ADDENDUM – INVITATION TO TENDER
FOR
INDIAN HEAD RESEARCH FARM
CONTRACT NO. 22 – BUILDING RENOVATIONS
CONTRACT #465-1-4-C22

Addendum No. 1

ADDENDUM #1

Project : Indian Head Research Farm Maintenance Building B017 Remodeling
Project No. : 4748
Date : March 12, 2015

M6.1

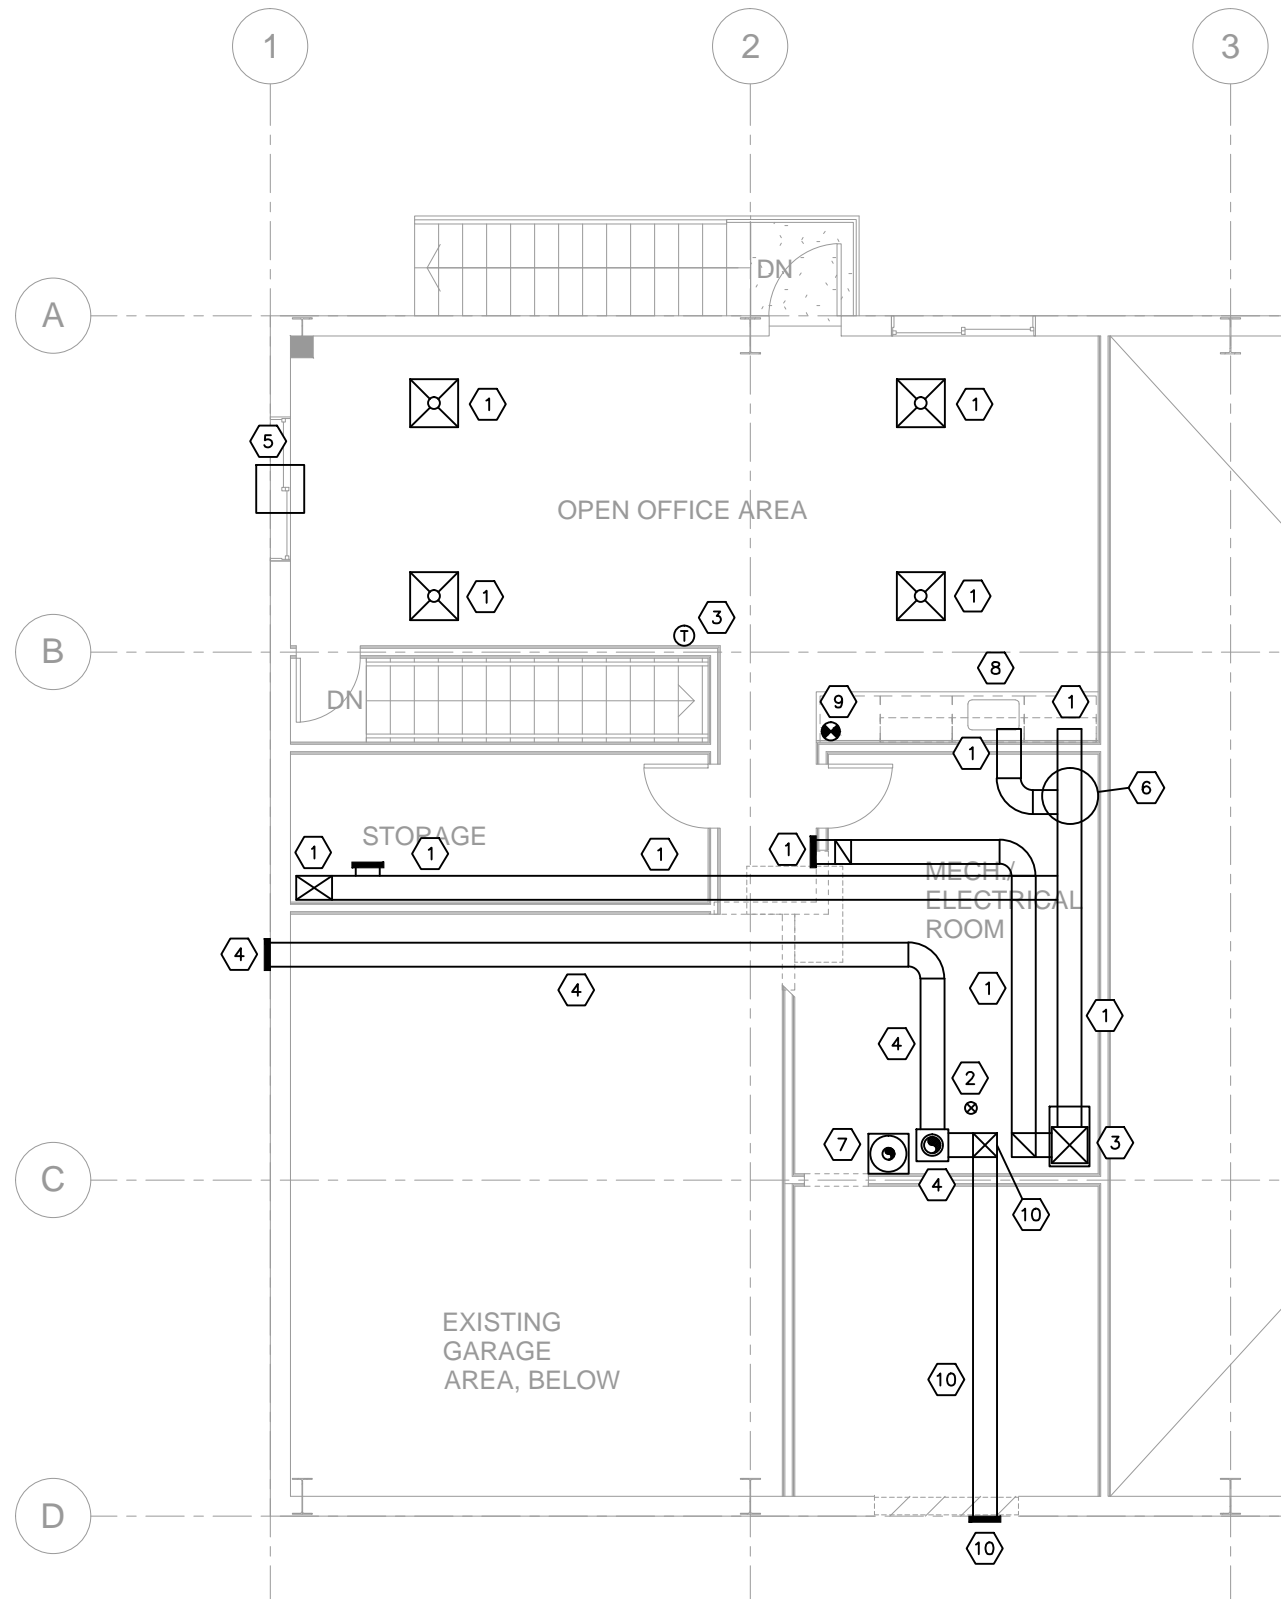
1. Replace the (5) Five Mechanical Drawings Sheets (M6.1 through M6.5) in the set, with the Updated Drawings issued under this Addendum No. 1. NOTE: additional key notes and information have been added on each mechanical drawing sheet, to offer better clarifications on the scope of work.
